Barma Water Resources Consulting Pty Ltd

# Focused Review of Floodplain Harvesting Modelling (Macquarie Regulated Valley)

August 2022

Figure 1 - FMZ Storage Behaviour - Event 1

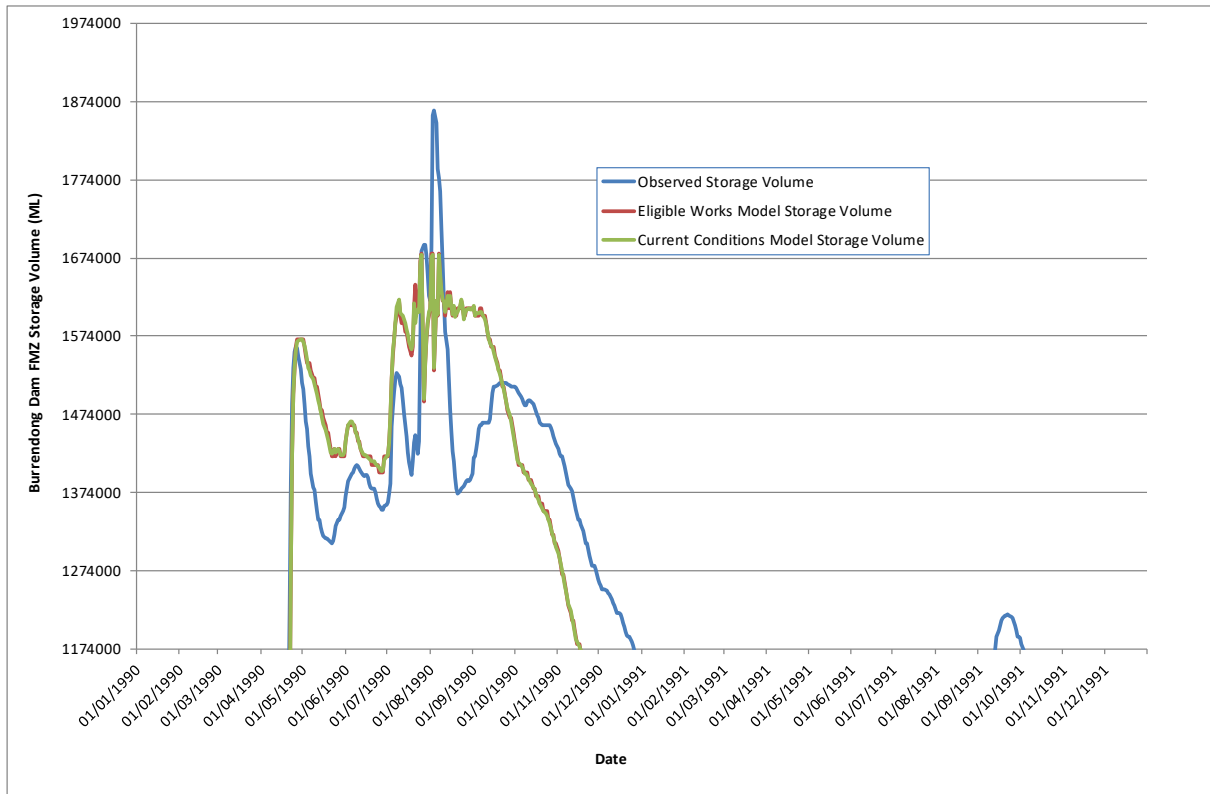
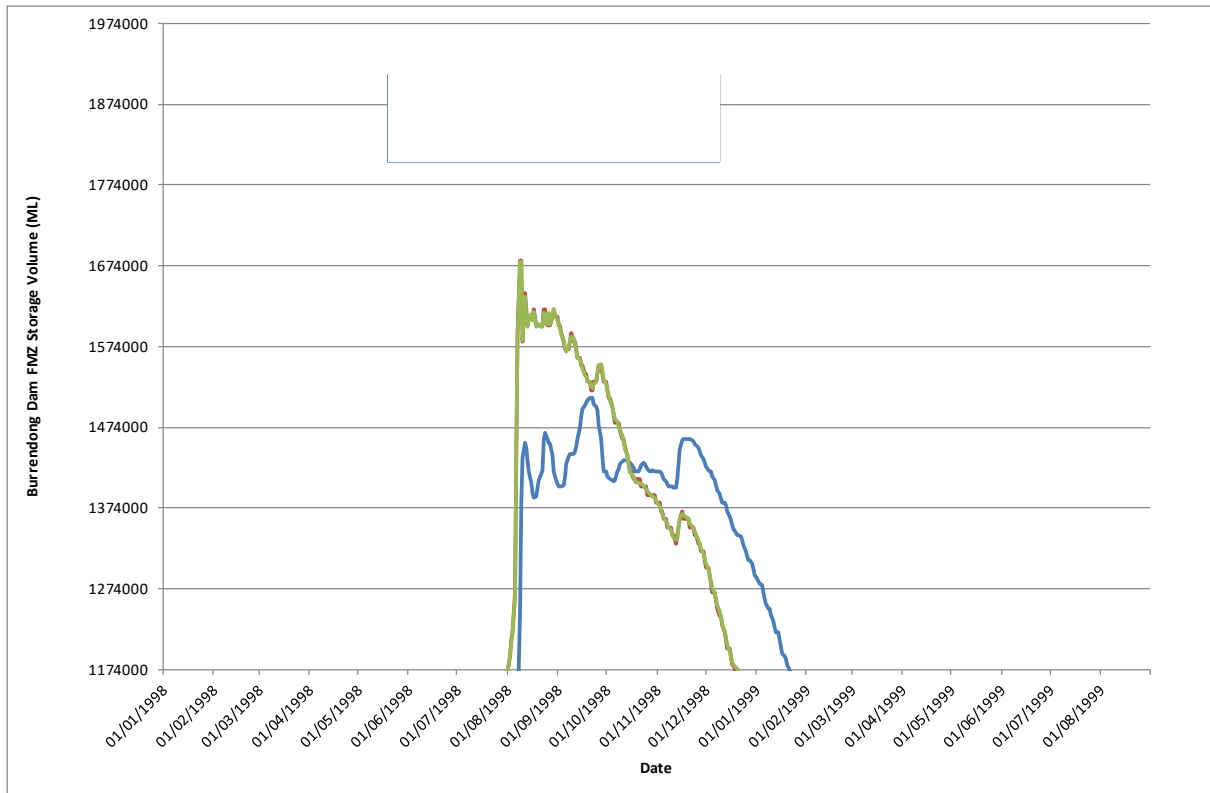
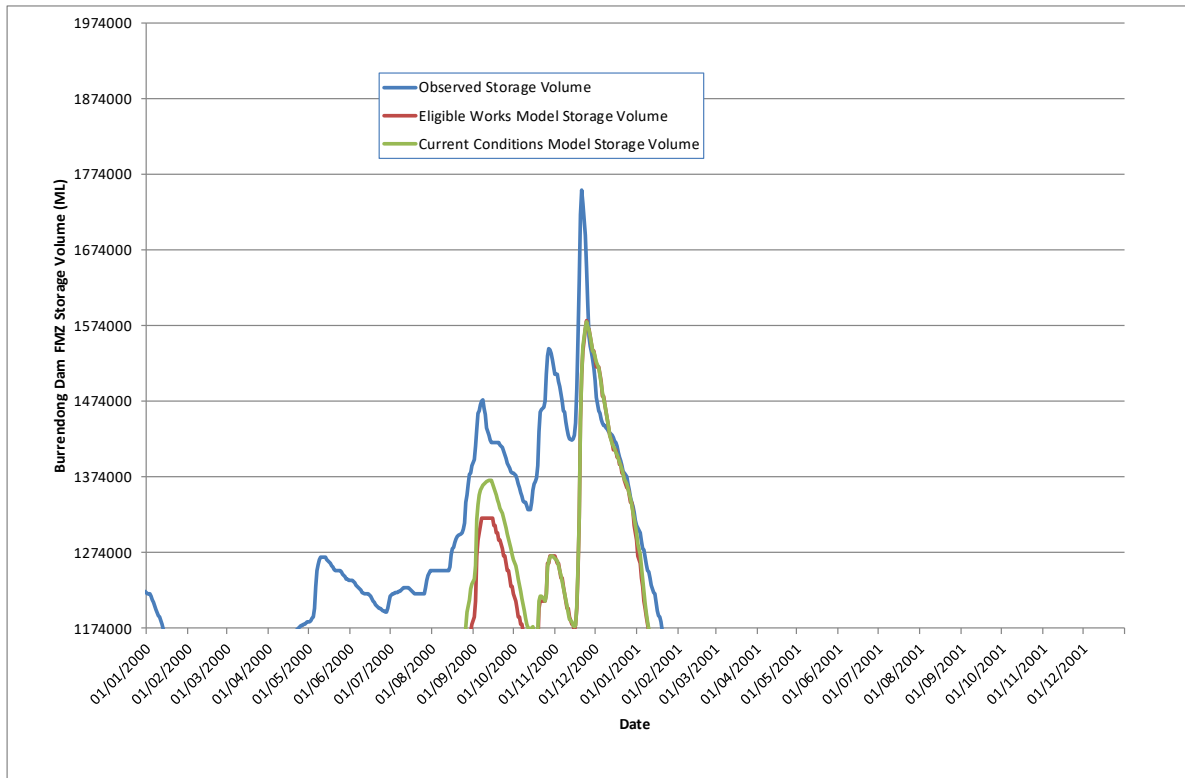
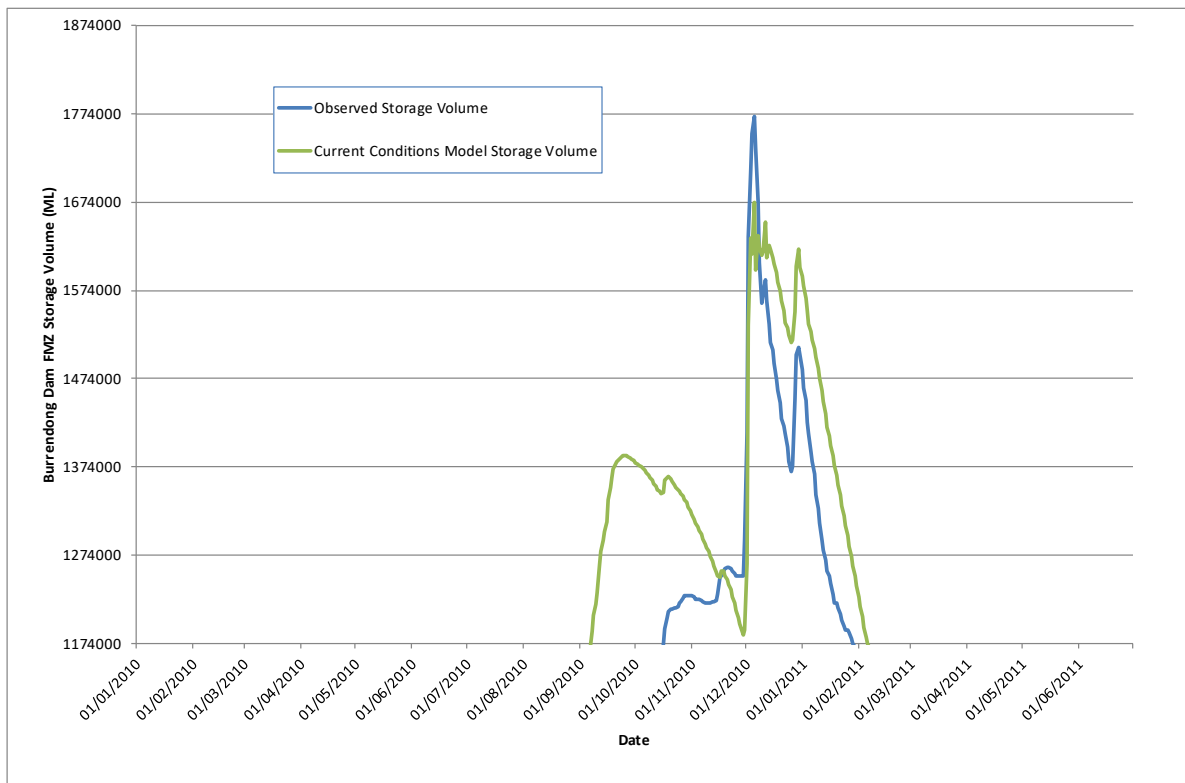
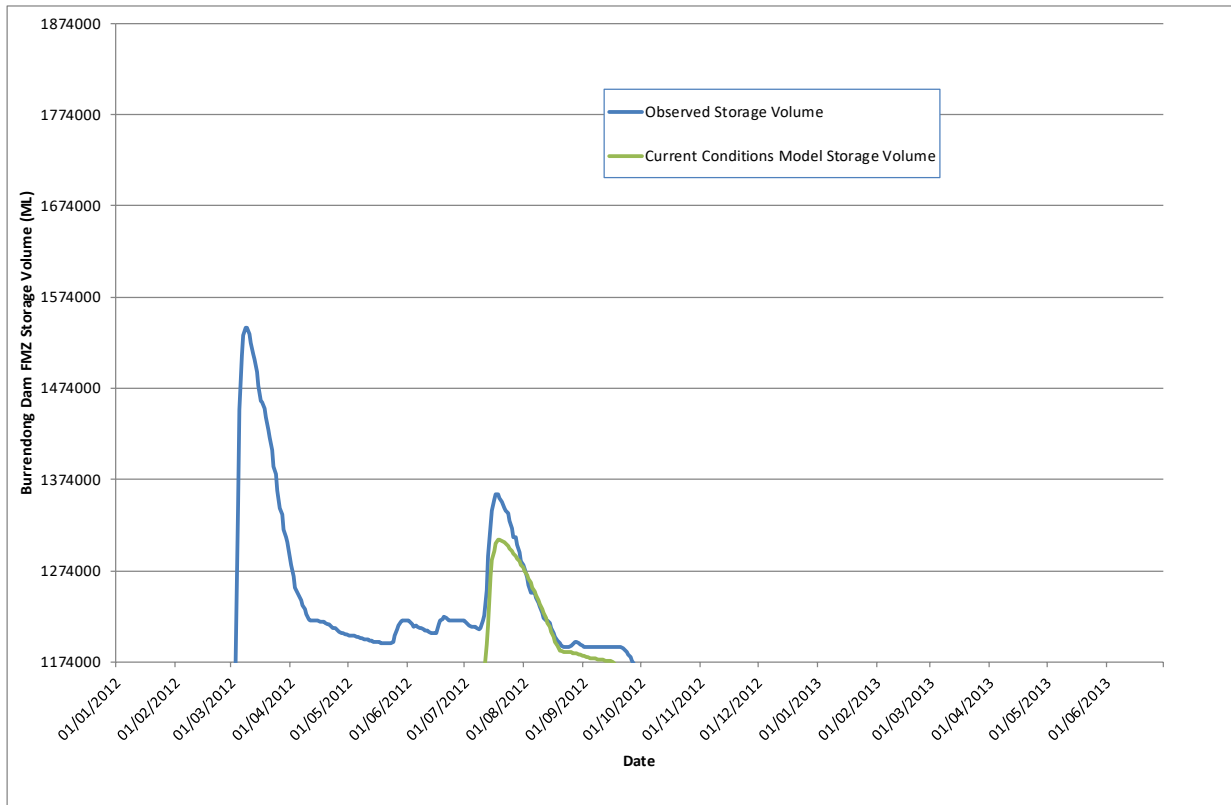
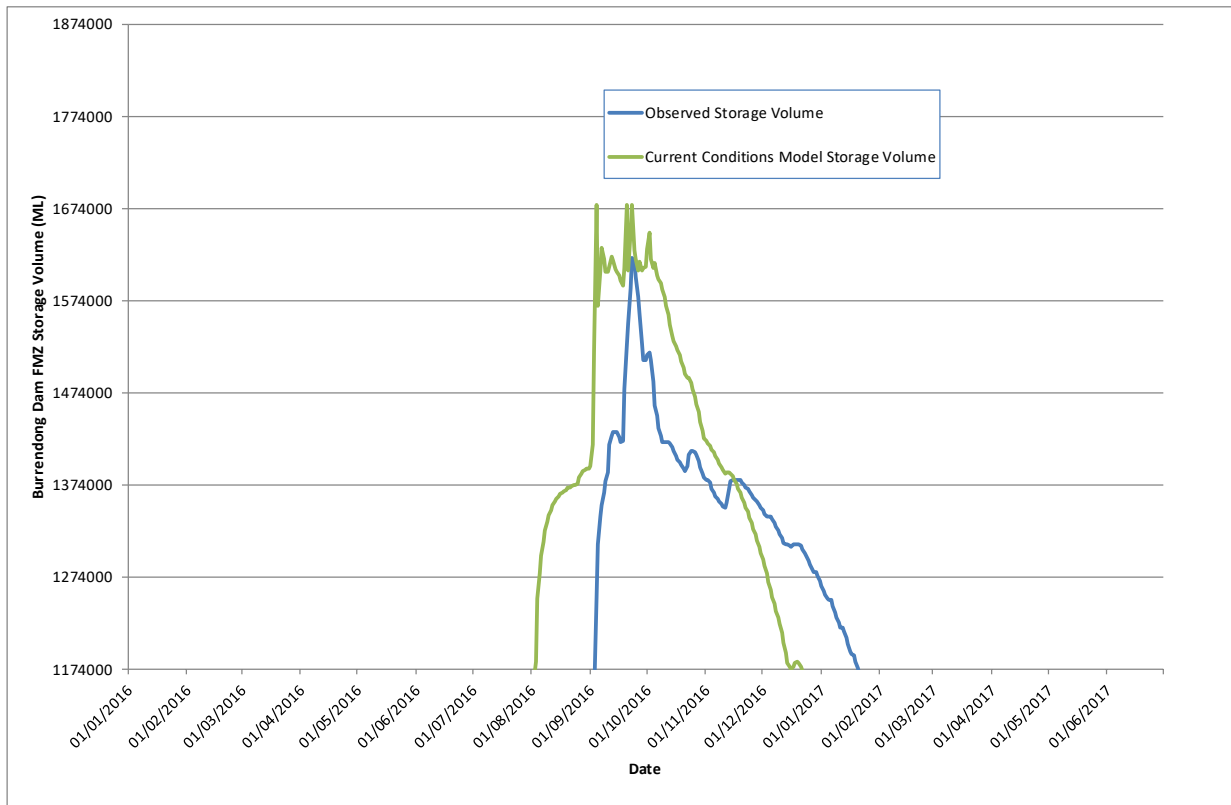
Comparisons of modelled and observed FMZ storage behaviour are presented in Figure 1 to Figure 6. Modelled results are shown for both the Eligible Works IQQM model and the Current Conditions IQQM model. The figures indicate that there are a number of occasions in which observed volumes seem to be held in the FMZ for about 4 weeks longer than modelled.

In order to determine the effect that longer FMZ storage times would have on floodplain harvesting diversions for the focus properties, a sensitivity analysis of Burrendong Dam FMZ release rates was performed. The results of this are presented in Table 1. The sensitivity assessment results indicate that holding volumes in the FMZ will increase floodplain harvesting diversions for six of the seven focus properties. However, the percentage increases are small. Importantly, although not shown in this table these changes in FMZ releases behaviour cause reductions in floodplain harvesting diversions for properties further upstream. The net effect across the total valley is an increase in floodplain harvesting diversions of just 1.3%

Figure 7 - Upstream Marebone Flow Duration Curve

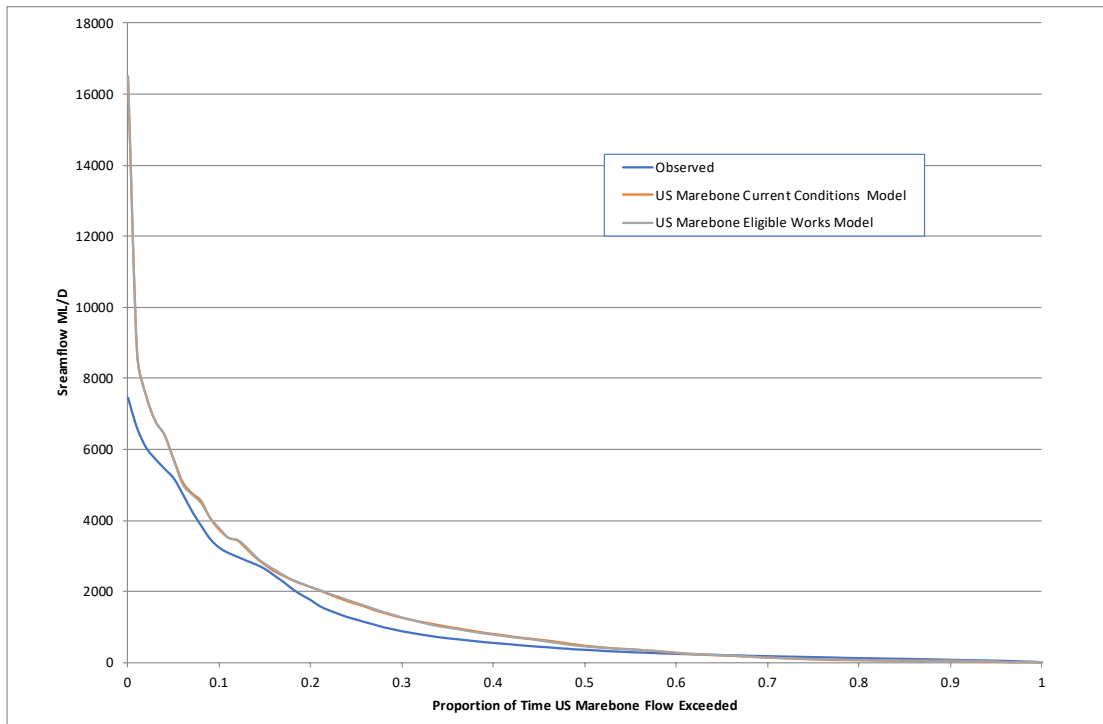
A number of observations are apparent from the results in Table 2 and Figure 7. Model simulated flows at Upstream Marebone occur more frequently than observed flows. This means that the model appears provides more access to floodplain harvesting flows than observed for the focus properties. This also remains true when modelled flows are compared to the data provided for focus farms by water users.

Given that the model appears to overestimate observed flows upstream of Marebone, no additional assessment of the model performance in simulating flows at Marebone, and the effect on floodplain harvesting diversion estimates was deemed necessary.

Figure 8 - Summer Planted Areas

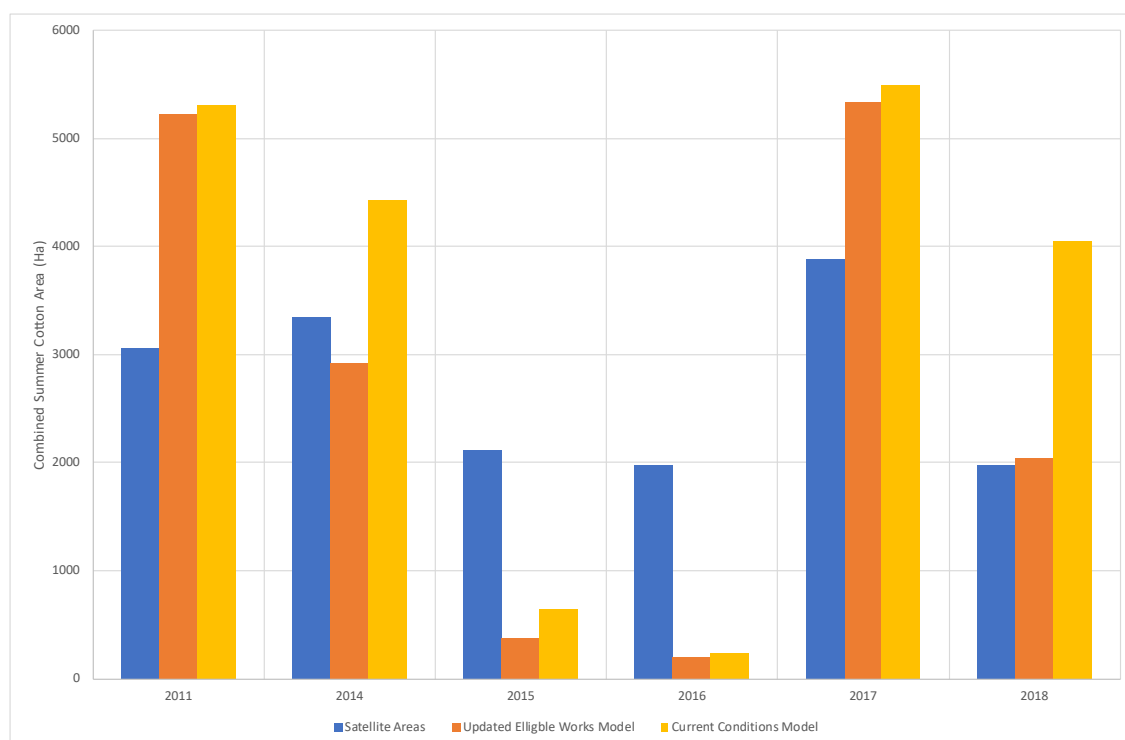
The results of Figure 8 indicate that the model appears to over predict summer cotton areas in years where the resource is plentiful, but under predict areas in years of resource scarcity. This trend was also observed for individual focus farms as shown by the results in the attached Appendix.

Figure 9 - Summer Planted Areas (Sensitivity)

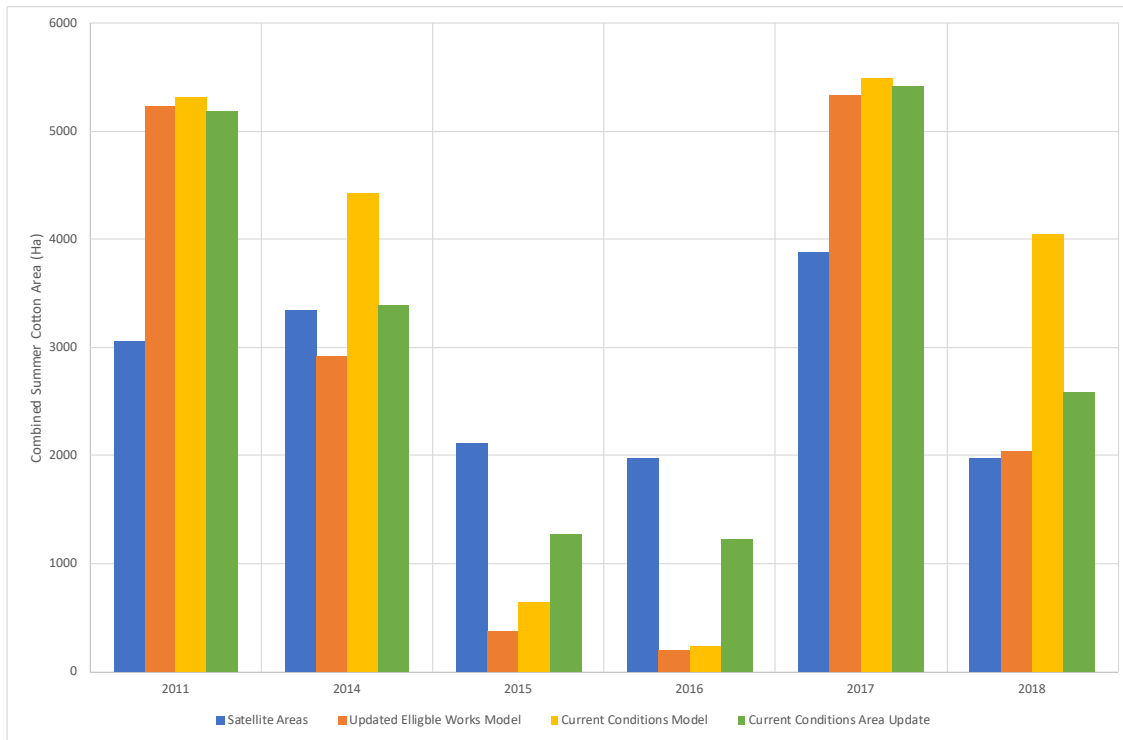
In order to determine the effect of this on flood plain harvesting diversions the planting decision in the model was modified by increasing the minimum planted summer area. The results of this are shown by the green bars in Figure 9. The results indicate an improvement in the match between modelled summer planted areas and those observed from Satellite imagery. The effect of this on floodplain harvesting diversions was determined after an assessment of winter area production.
